INDESIT company

Model type:
MTA4512VGR

Commercial code:
F029352

RE0207T0 Exploded views

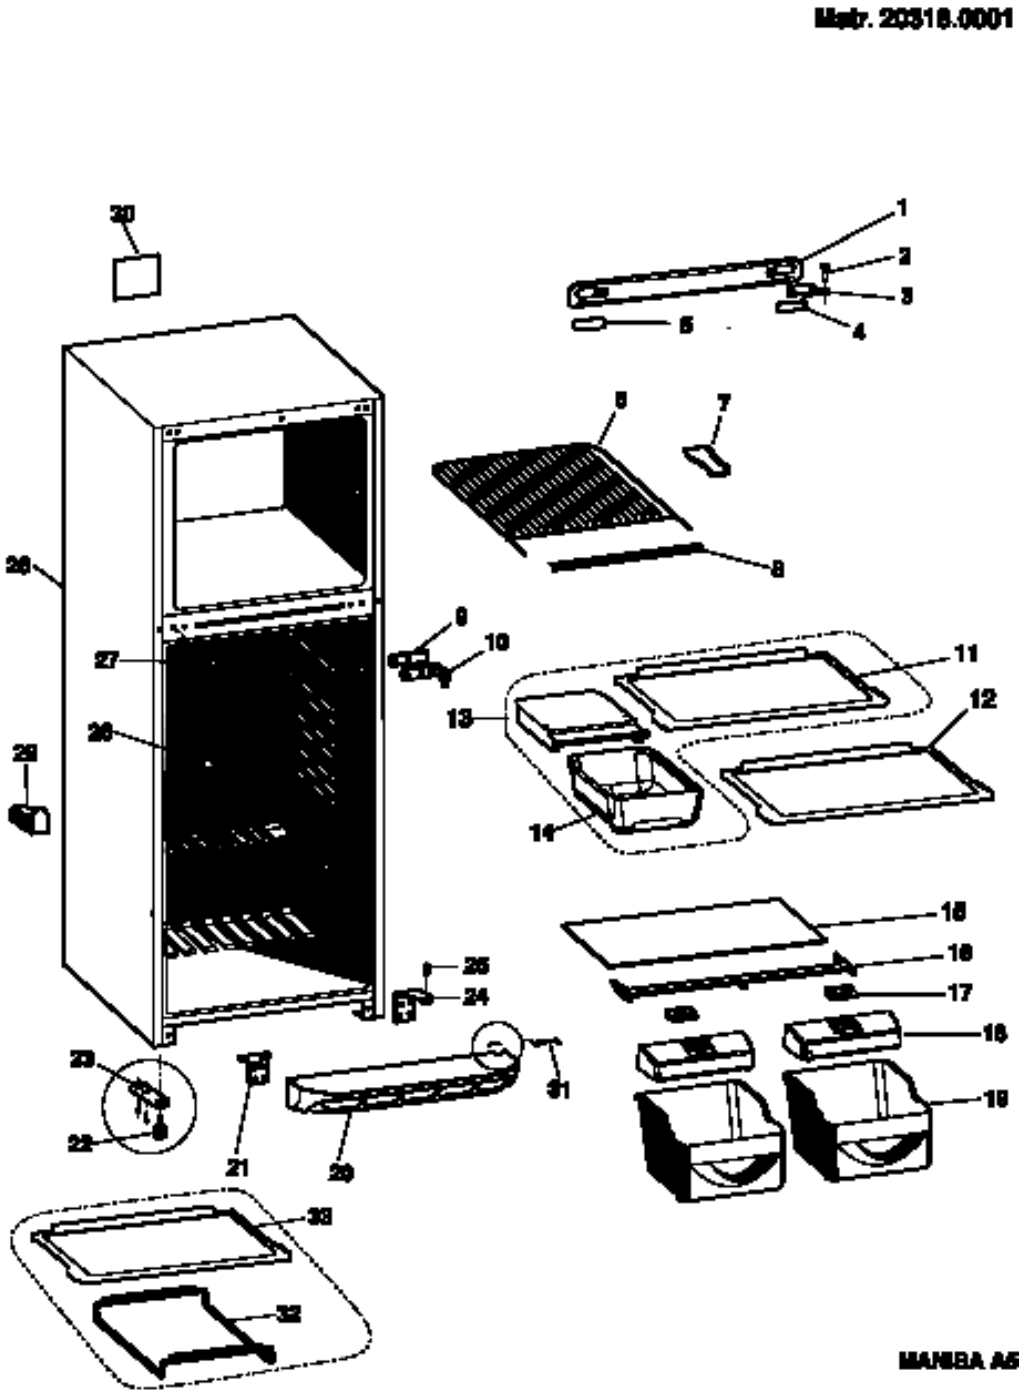
0999357: plastic compressor basement

Plastic compressor basement will be used on refrigerators since this reason adjutable foot and except single door bottom hinge have been changed. New hinge will be managed with a new code. The new bottom hinge can be used on both left and right sides.

New adjustable foot;
89682- white
89686- black

New bottom hinge assembley with adjustable foot;
110081- white
110522 - black

RE0208T0 Exploded views

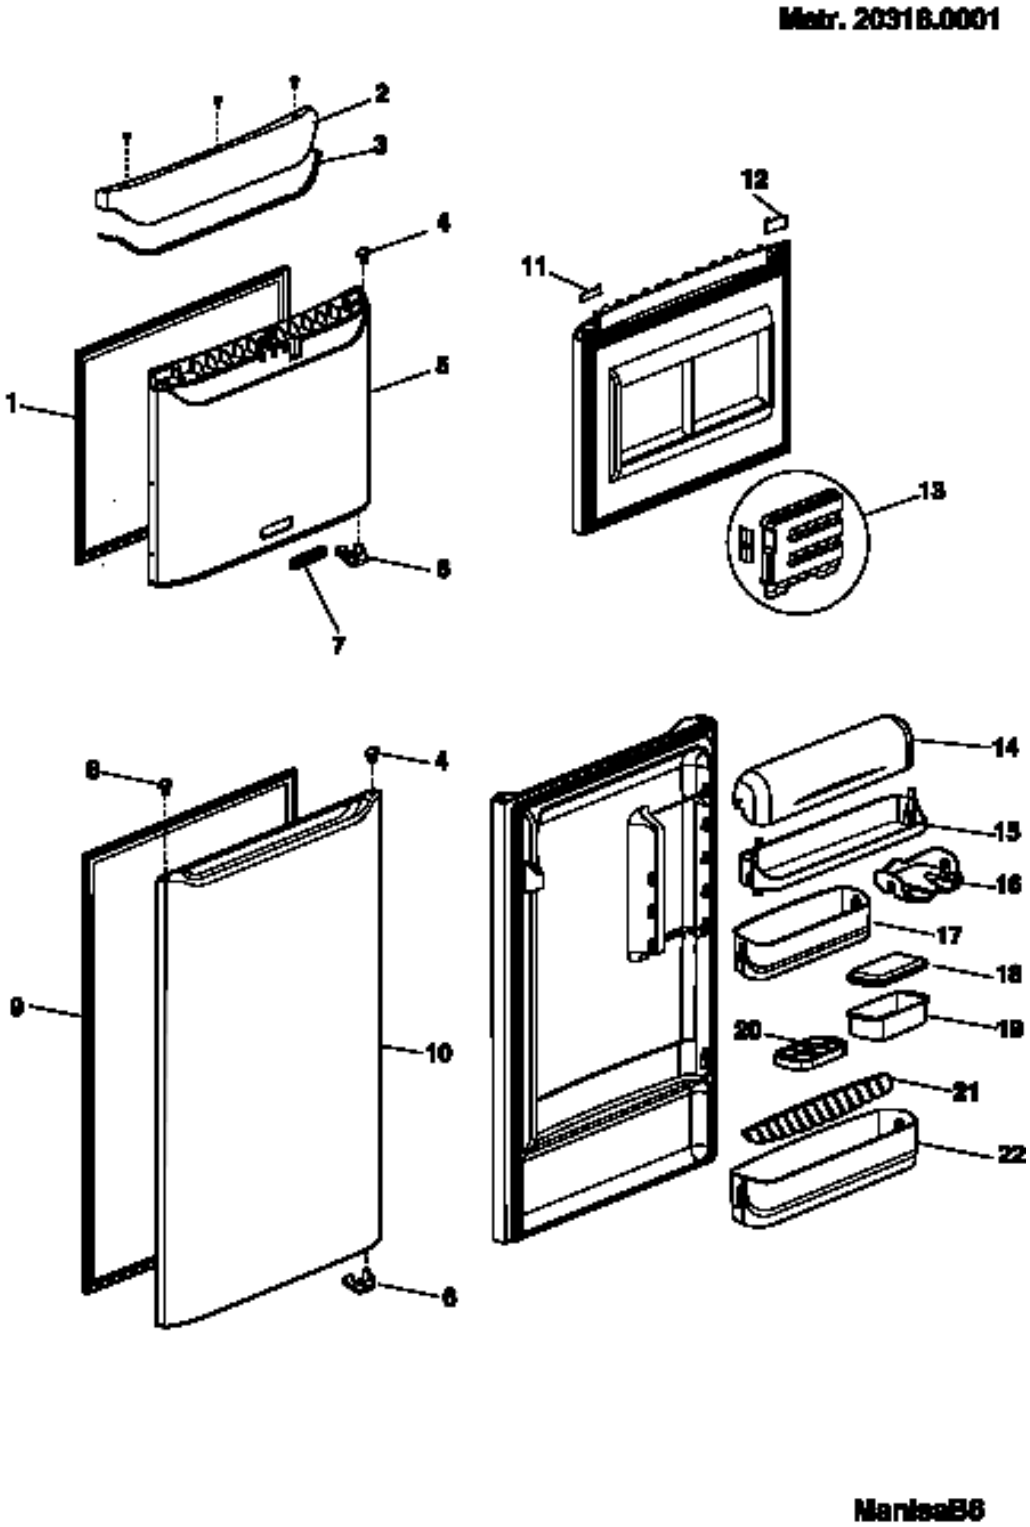
0999368: color modification

Since April 2005, color of products has been changed from Bianco 27 to Polar White in Manisa Plant.

External colored parts

New spare part codes have been given for the below external parts.

Cabinet, cabinet head panel, door, door head panel, door gasket, kick plate.

The external parts colered bianco 27 are limited with our stock and in the future it will be substituded by polar white parts.

RE0209T0 Exploded views

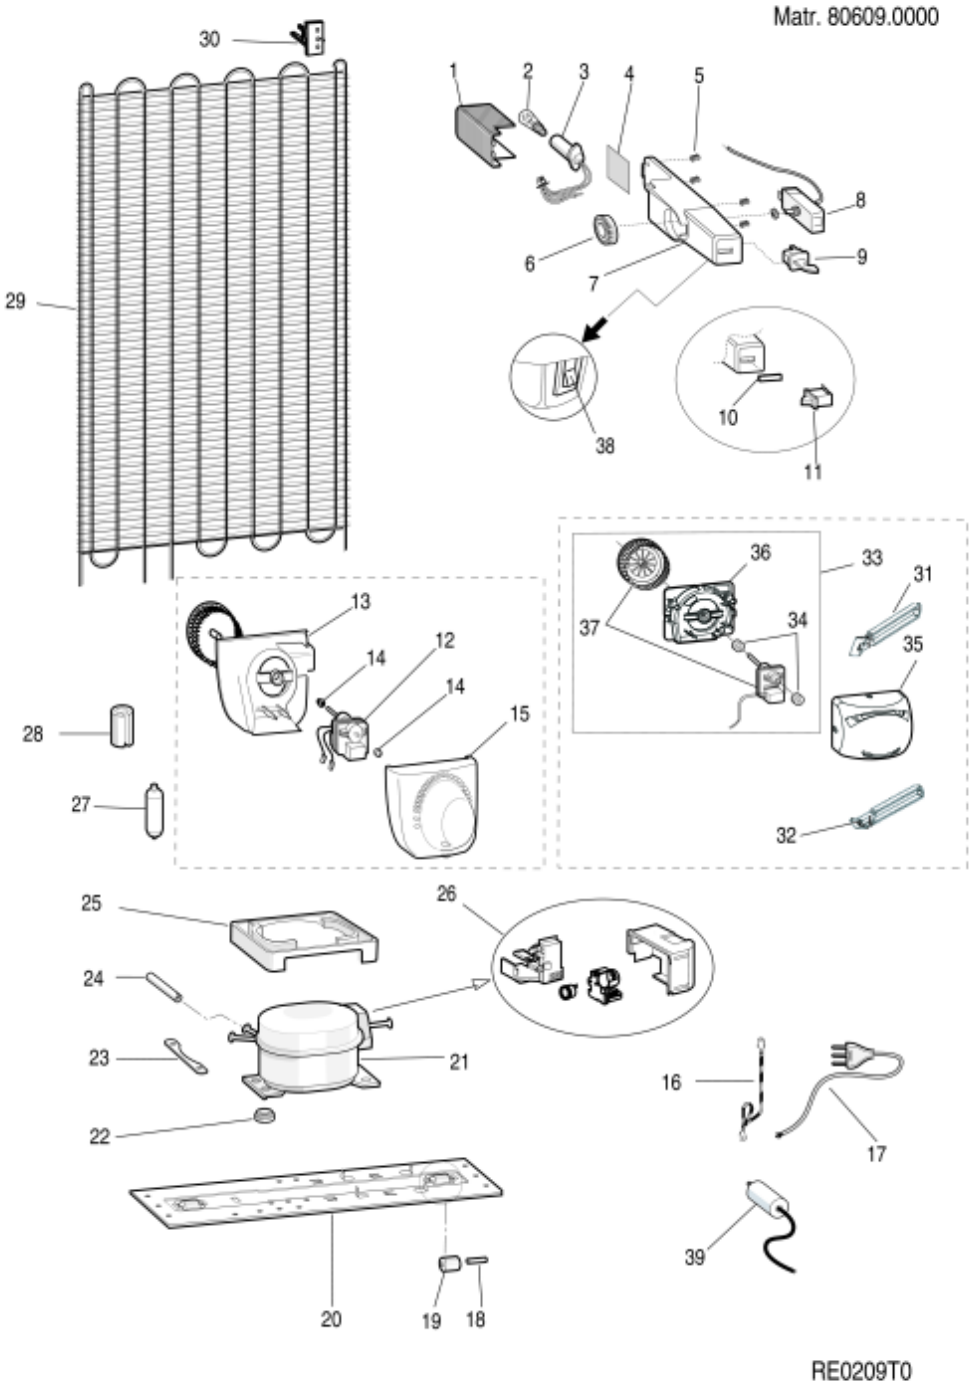
n2510b00: SUBSTITUTION RUBBER BUFFER FOR COMPRESSOR

Since month of February 2010 has been substitute in assistance the rubber buffer for compressor C00089673 with the C00109592.
Substitution is not valid for the products which use JIAXIPERA compressors respectively differentiate for type, Single Door (SD) / Double Door (DD) or different:

SD/DD C00089673 --> C00277320
NOT SD/DD C00089673 --> C00032453
